ROADWAY CONSTRUCTION

INTERSTATE ROUTE H-1
PROJECT NO. I-IR-HI-1(169):17

SCALE: 1" = 50' DATE: 3/15/82
SHEET No. C-1 OF 17 SHEETS

"AS-BUILT"

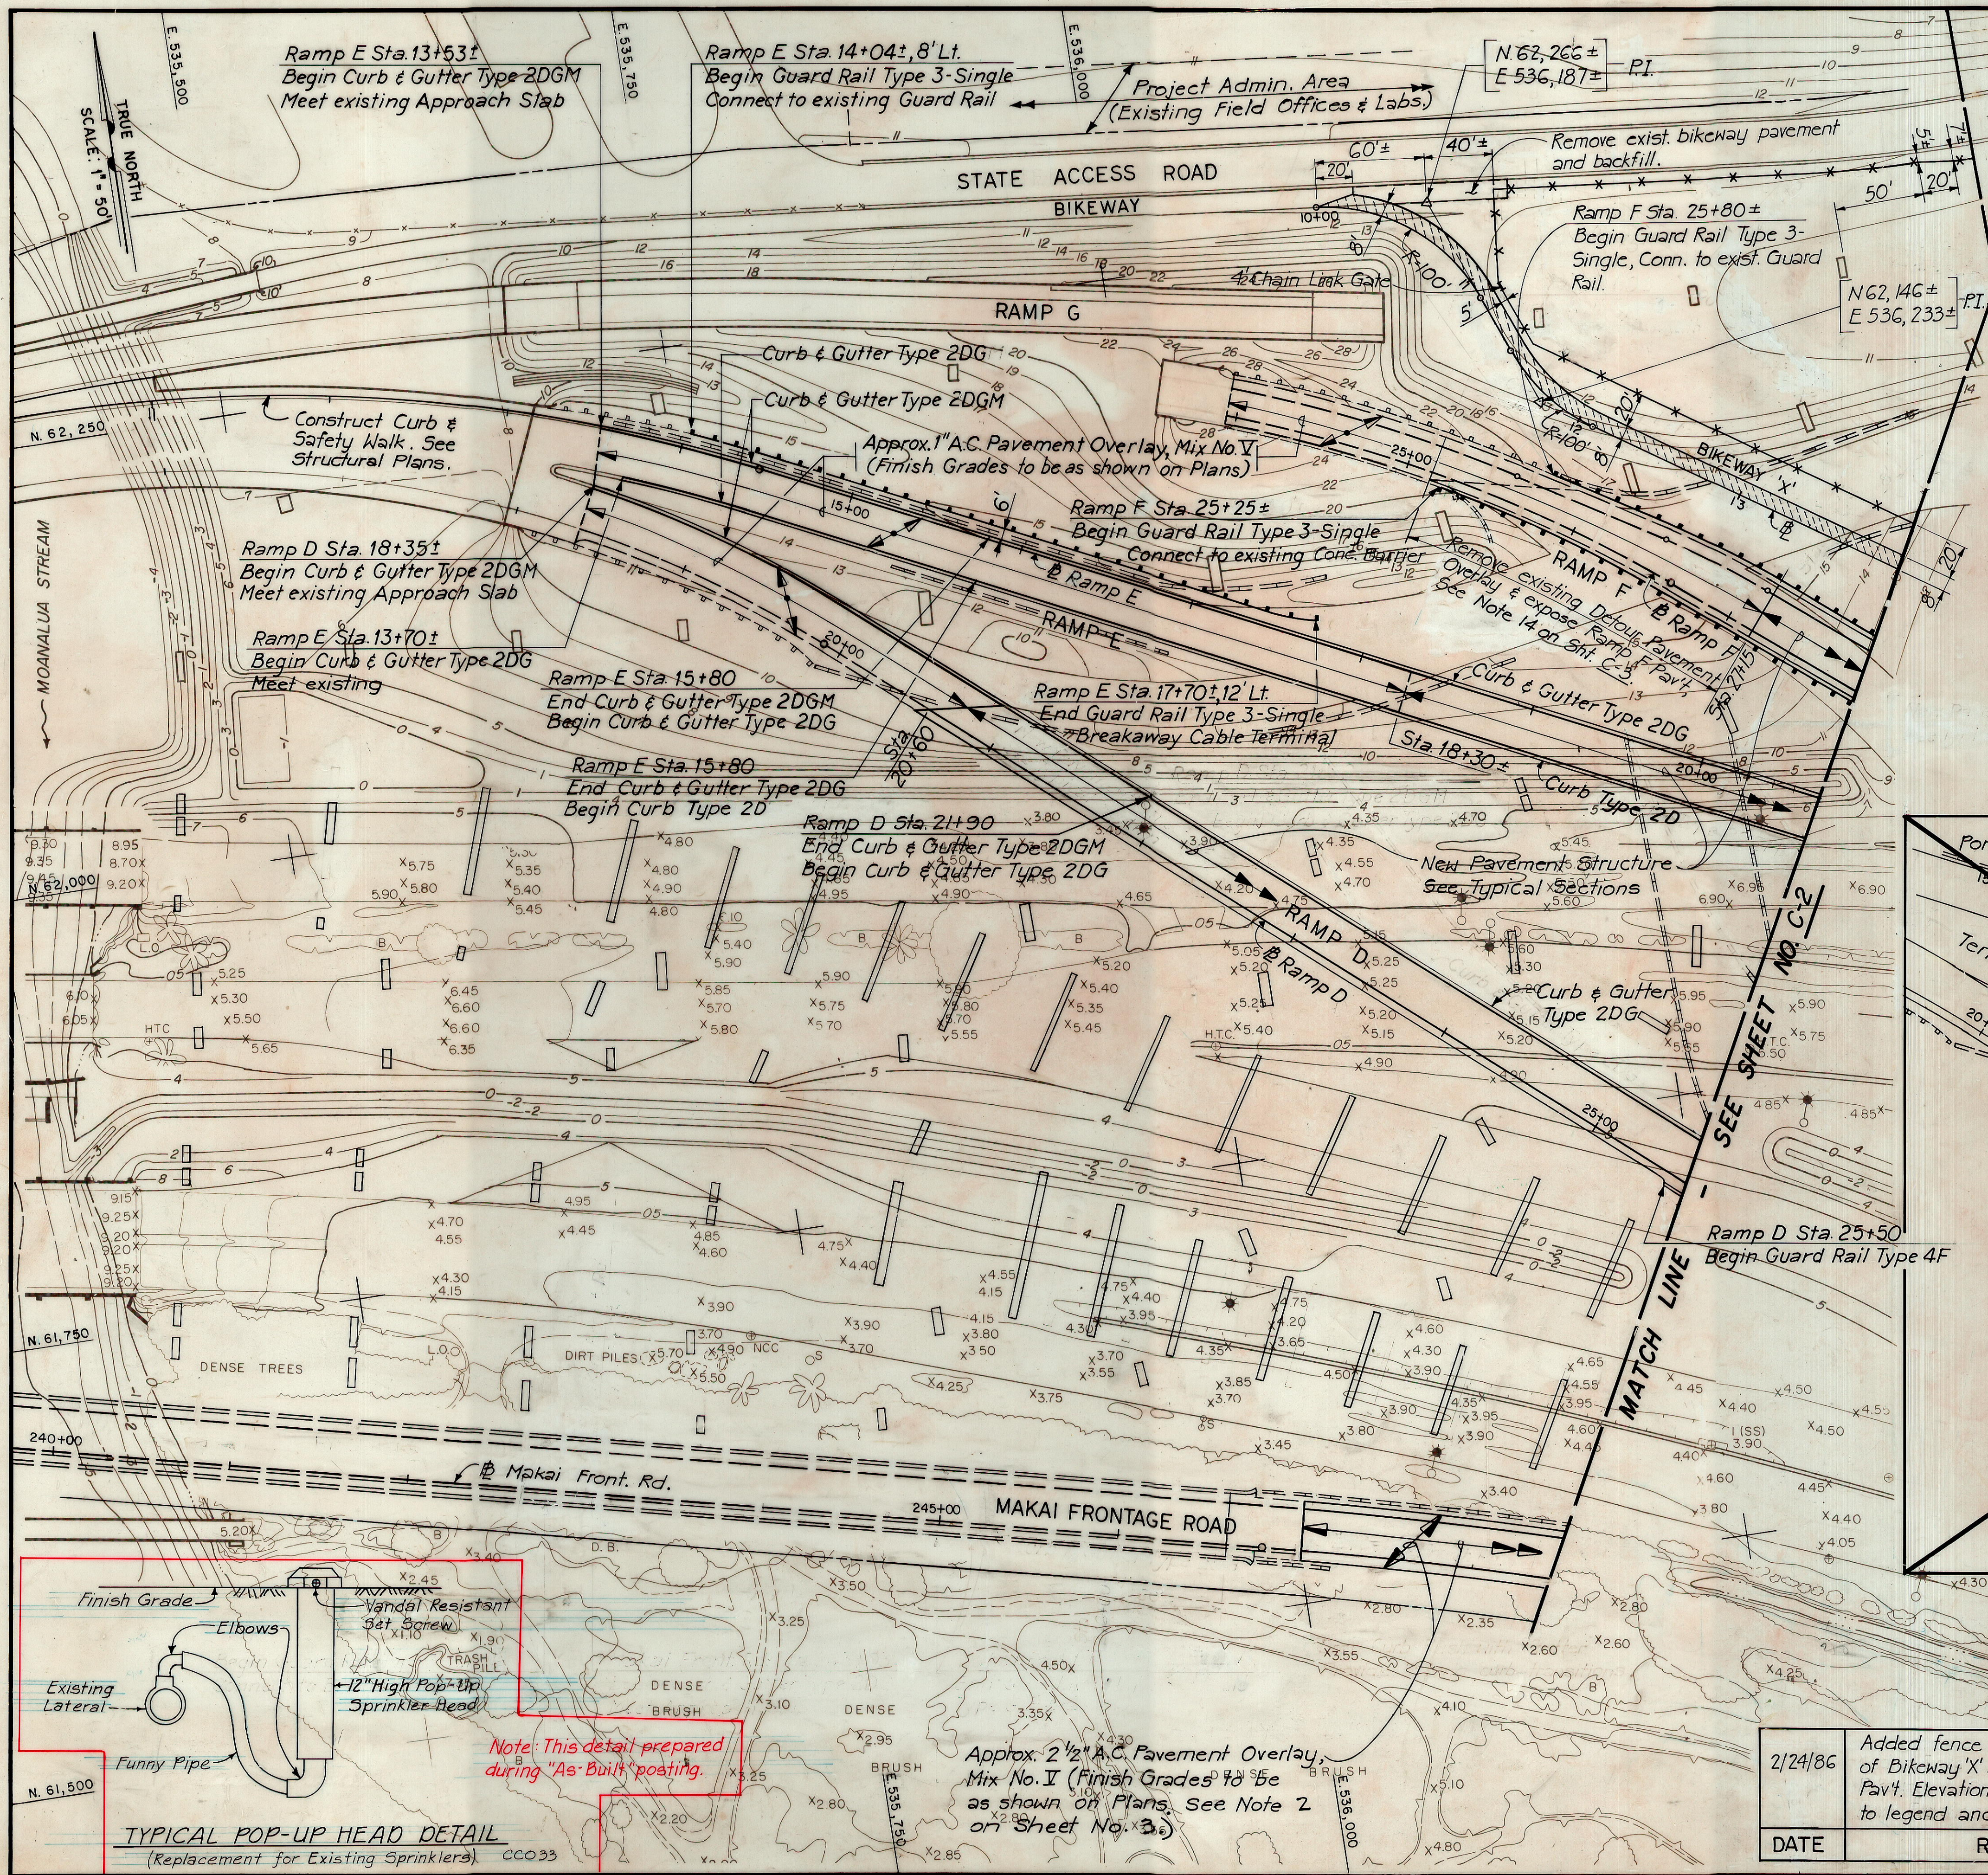
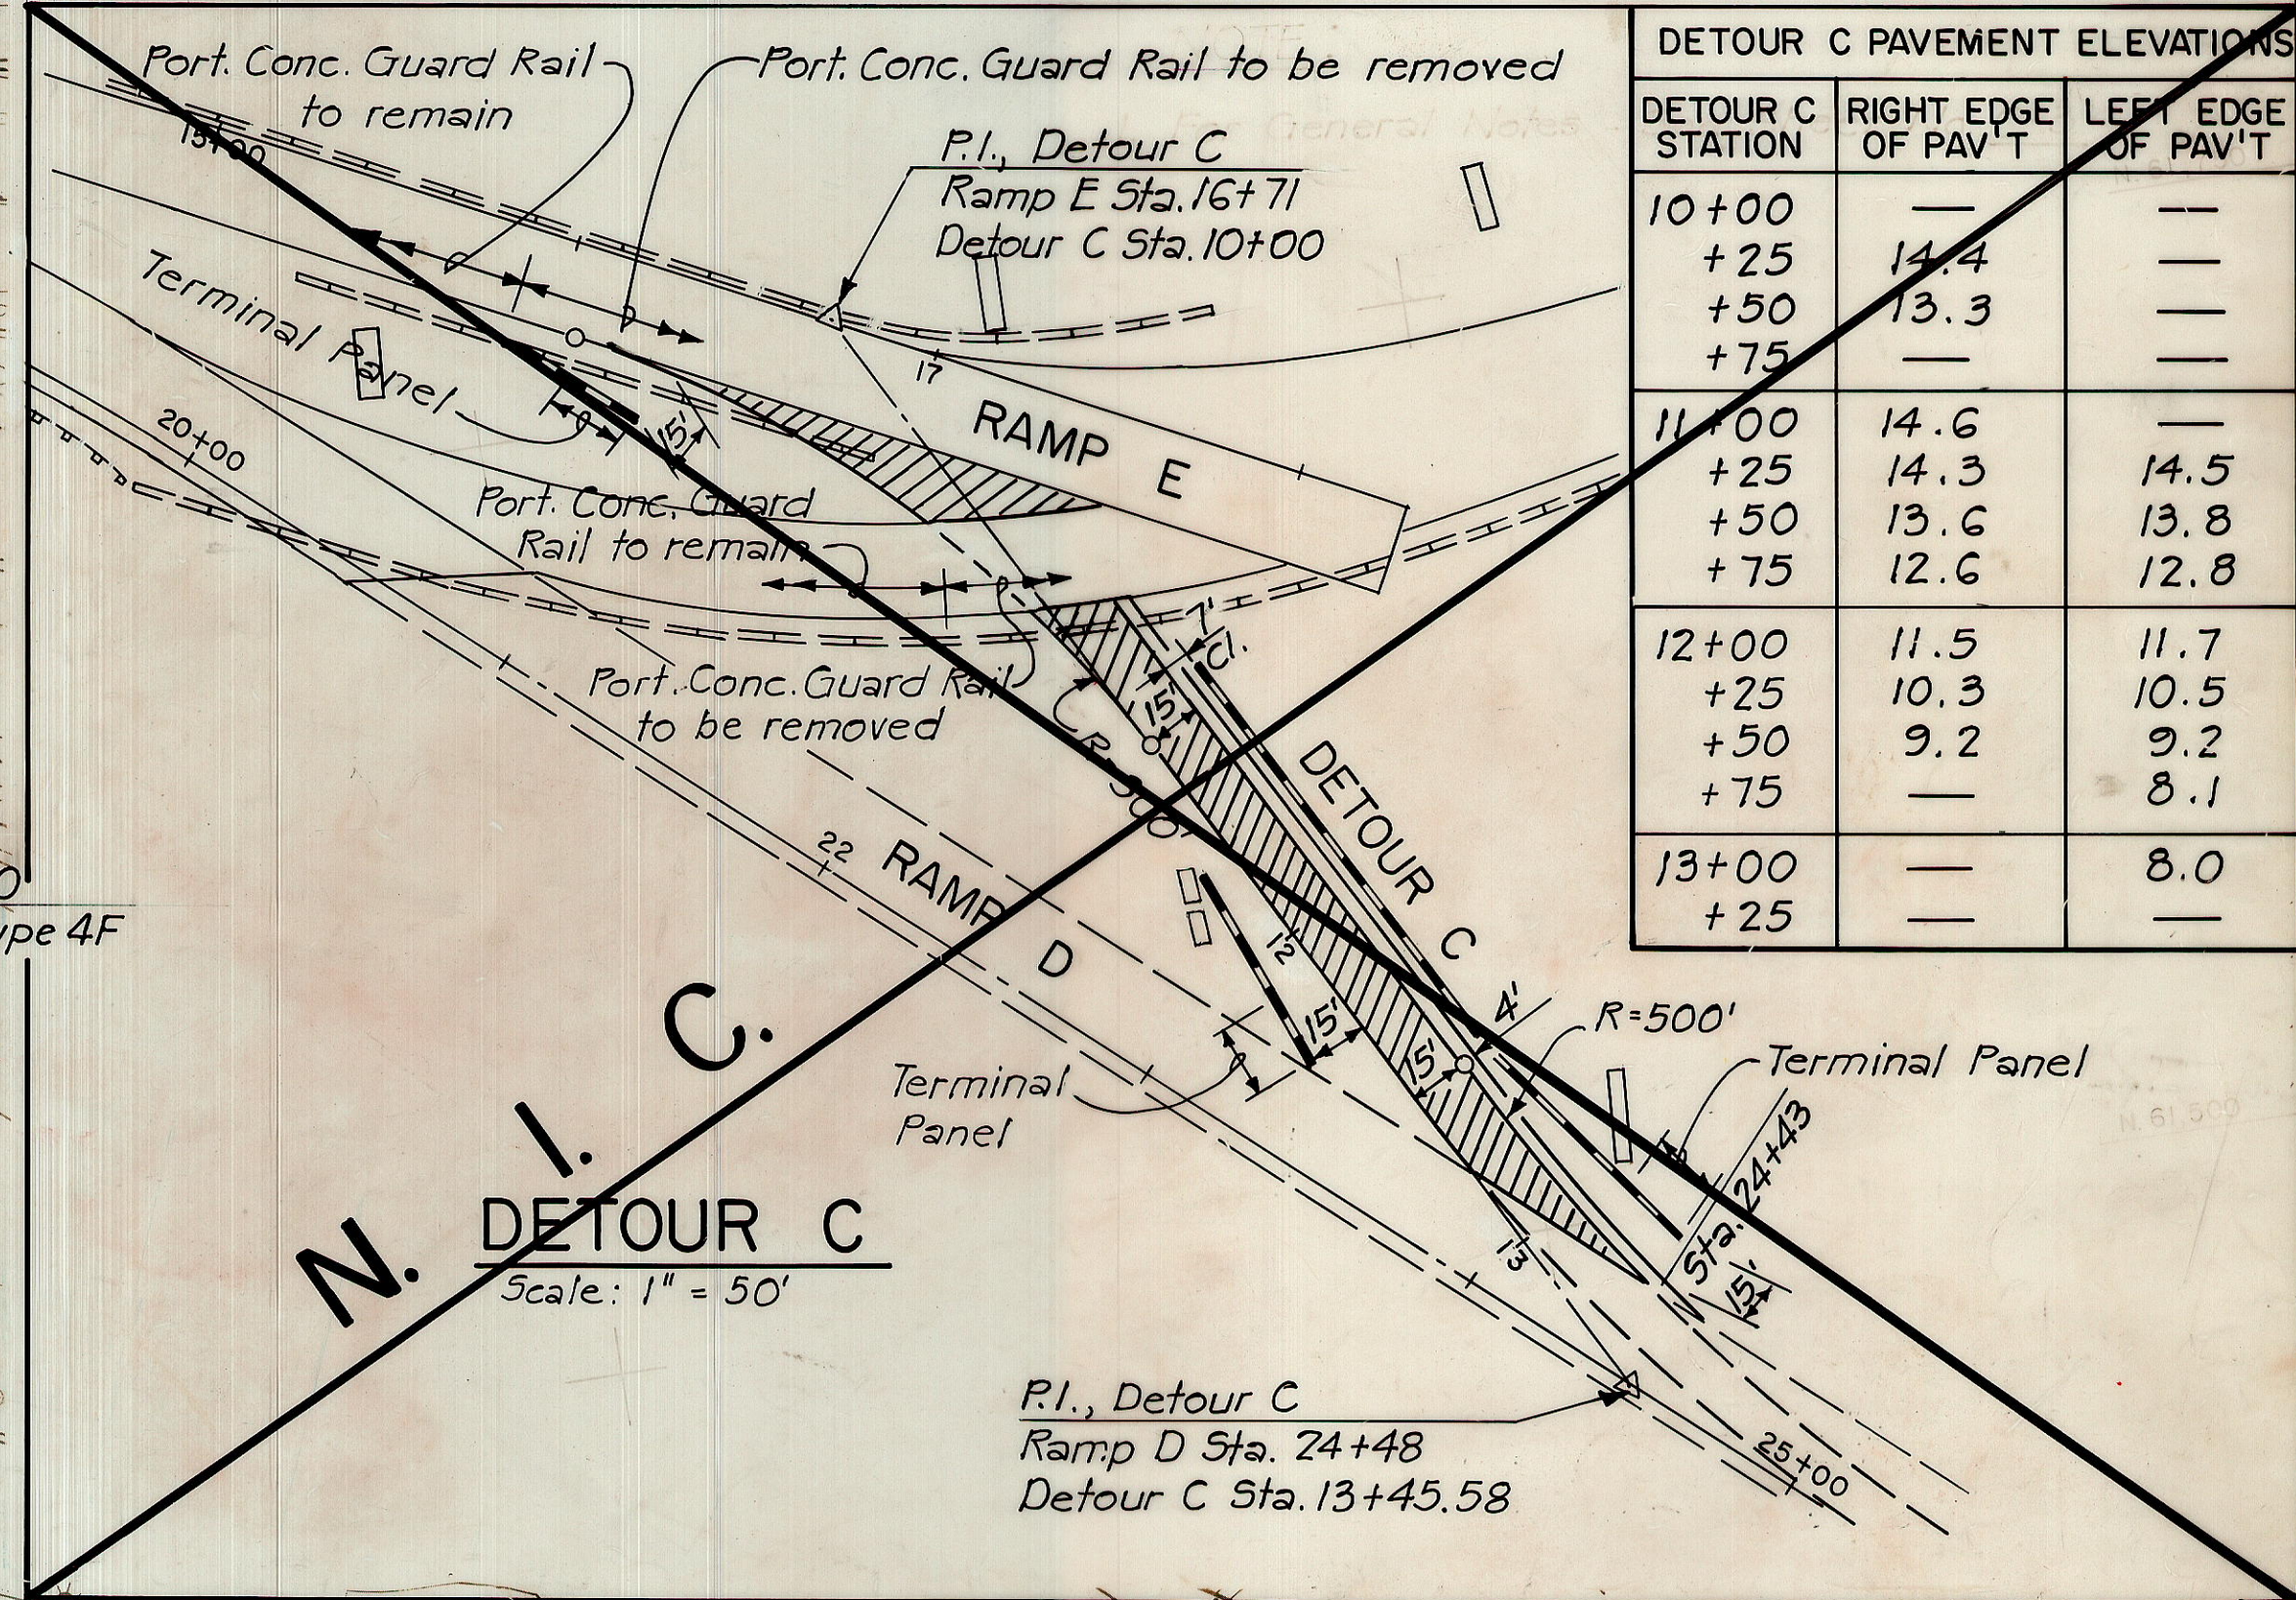
2/24/86	Added fence and changed location of Bikeway 'X'. Revised table "Bikeway 'X' Pavt. Elevations". Added fence symbol to legend and Note 2.
DATE	REVISION

SHEET No. C-2 OF 17 SHEETS

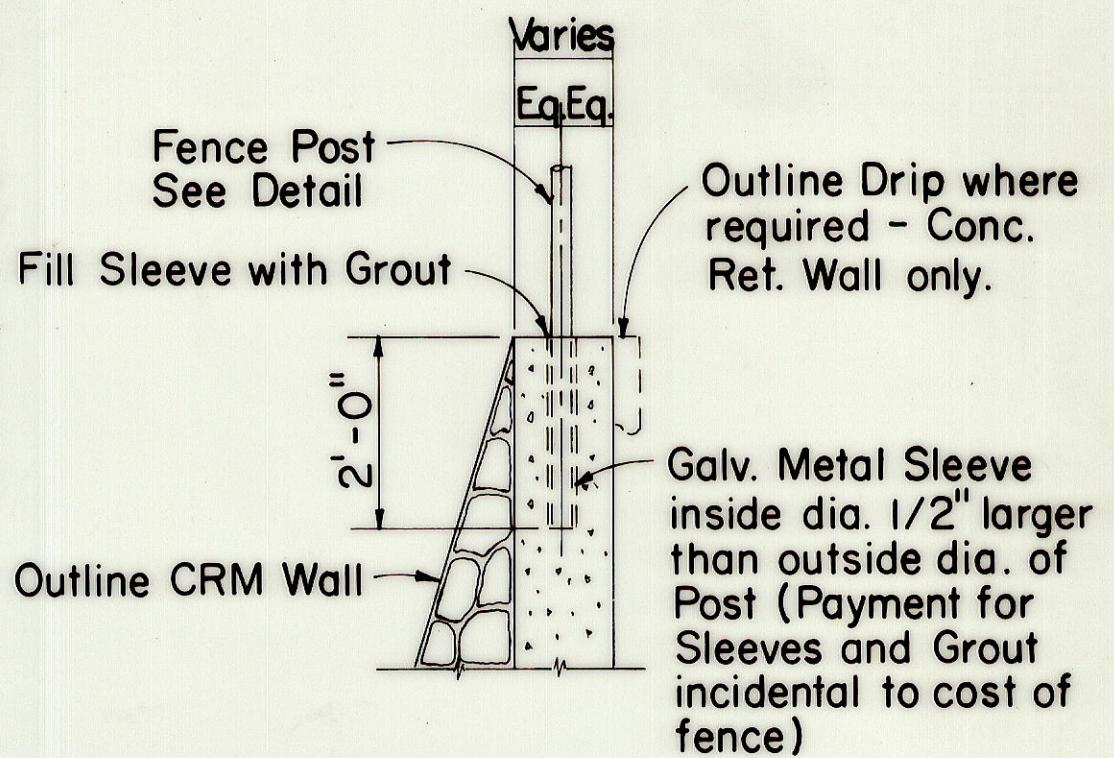
Added fence and changed location of Bikeway 'X'. Revised table "Bikeway 'X' Pav't Elevations". Added driveway at State Access Road. Added Note 3.
